Subject: UniStar Nuclear Energy, NRC Docket No. 52-016  
Calvert Cliffs Nuclear Power Plant, Unit 3  
Intake Structure Relocation Changes for Environmental Report

**Cross Reference of ER and FSAR Figures  
CCNPP Unit 3 Environmental Report  
Intake Structure Relocation**

**Revised Text and Figures  
CCNPP Unit 3 Environmental Report  
Intake Structure Relocation**

FIGURE 3.4-3  
CIRCULATING WATER INTAKE/DISCHARGE  
STRUCTURE LOCATION PLAN  
FOR CCNPP UNIT 3.

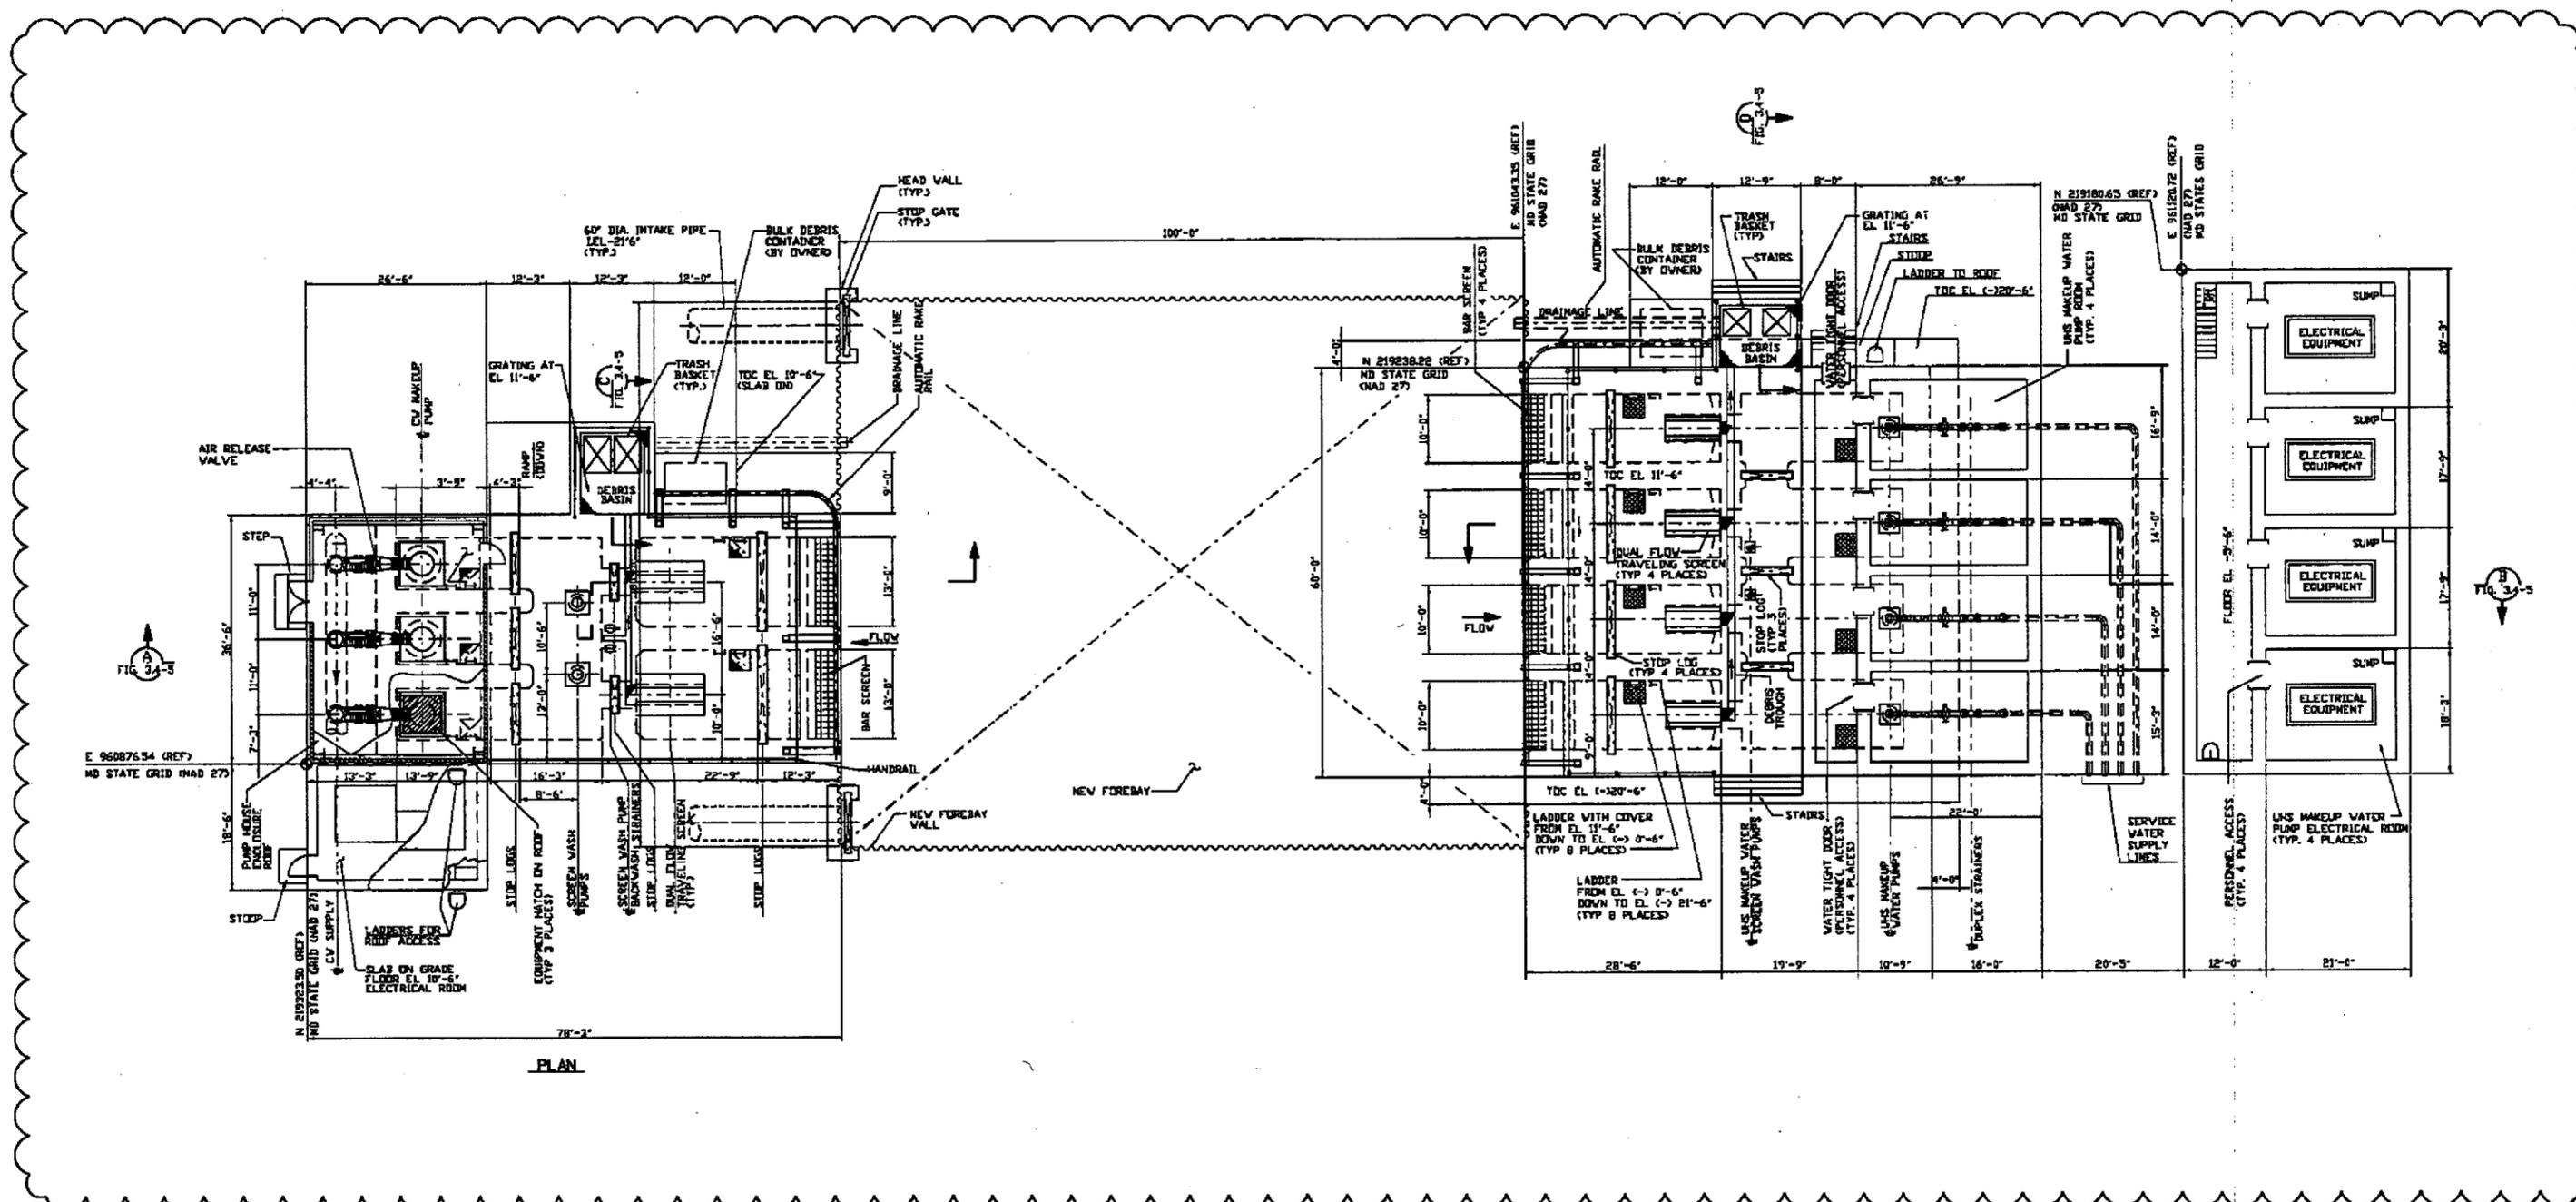
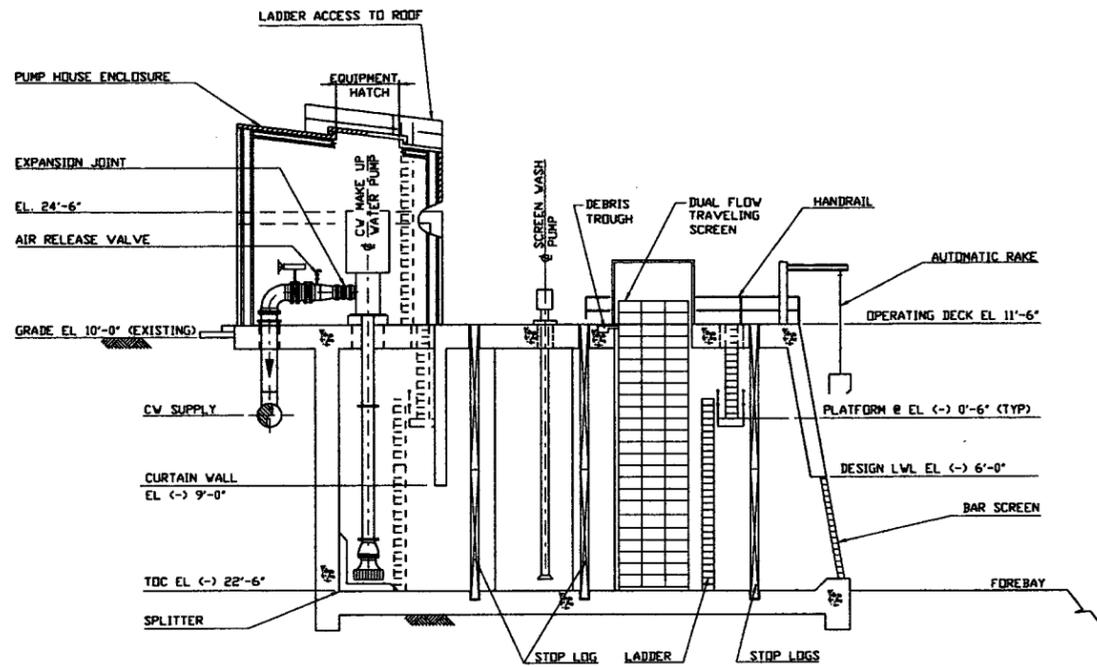
~~The intake channel will be an approximately 100 ft (30.4 m) long, by 123 ft (37.5 m) wide structure, with an earthen bottom at elevation -20 ft, 6 in (-6.2 m) msl, and vertical sheet pile sides extending to elevation 10 ft (3.0 m) msl. The general site location of the new intake system is shown in Figure 3.1-3, while Figure 3.4-2 and Figure 3.4-3 show the intake structure and channel in more details.~~

The CCNPP Unit 3 intake piping consists of two runs of 60-inch diameter safety related concrete pipes approximately 490 ft (149.4 m) long. These pipes convey water from the CCNPP Units 1 and 2 intake channel to a common forebay approximately 100 ft (30.48 m) long, 80 ft (24.38 m) wide structure with an earthen bottom at Elevation -22 ft 6 in (-6.86 m) NGVD 29 and vertical sheet pile sides extending to Elevation 10 ft (3.05 m) NGVD 29. The nonsafety-related CWS intake structure and the safety-related UHS makeup water intake structure are situated at opposite ends of the common forebay.

FIGURE 3.4-4  
 PLAN VIEW OF CHESAPEAKE BAY INTAKE SYSTEM  
 FOR CCNPP UNIT 3

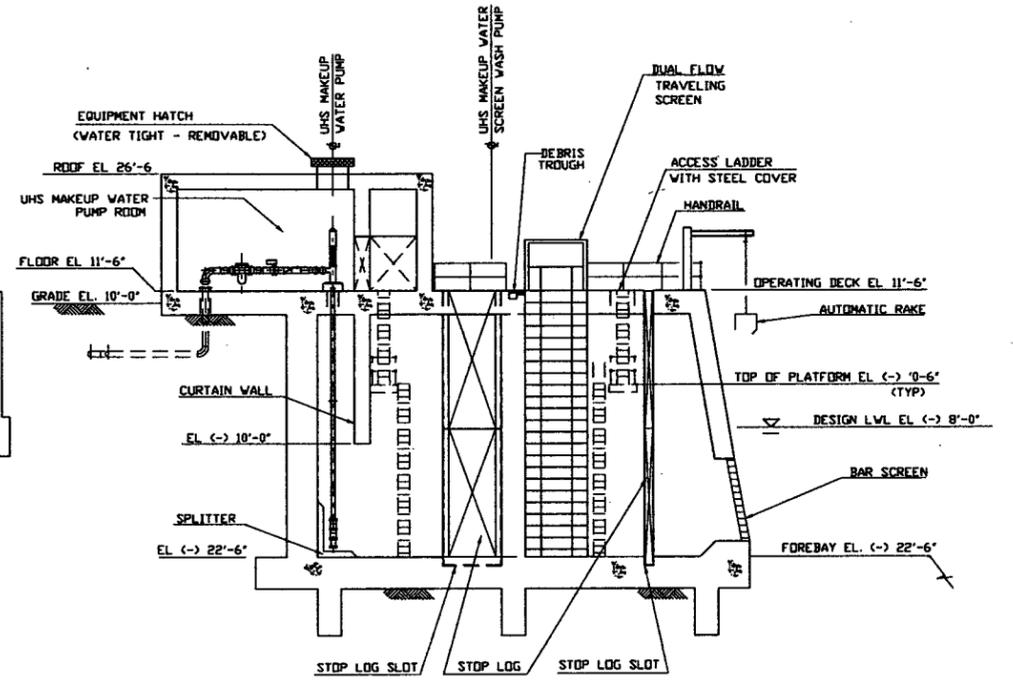
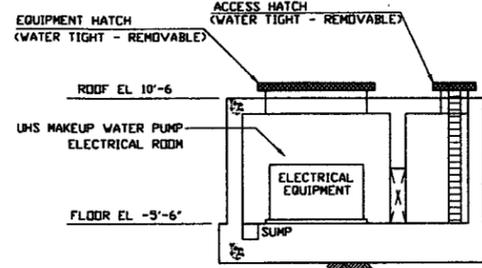
The new CCNPP Unit 3 CWS makeup water intake structure will be an approximately 78 ft (24 m) long, 55 ft (17 m) wide concrete structure with individual pump bays. Three 50 percent capacity, vertical, wet pit CWS makeup pumps provide makeup water.

75 ft (22.9 m) long, 60 ft (18.3 m) wide concrete structure with individual pump bays. Four 100 percent capacity, vertical wet pit UHS makeup pumps will be available to provide saltwater makeup water.
